Informal document No. **GRSP-37-14** (37<sup>th</sup> GRSP session, 23-27 May 2005 agenda item B.1.1.)

## Draft Corrigendum to ECE Regulation n° 14 (Anchorages of safety belts)

## Transmitted by the expert from CLEPA

## Annex 9 figure 7 amend to:

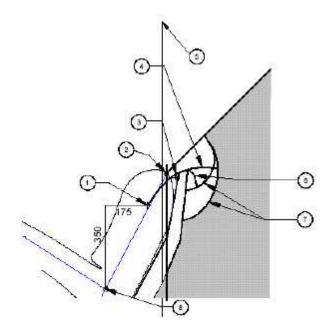
Only figure 7 of Annex 9 needs the following correction:
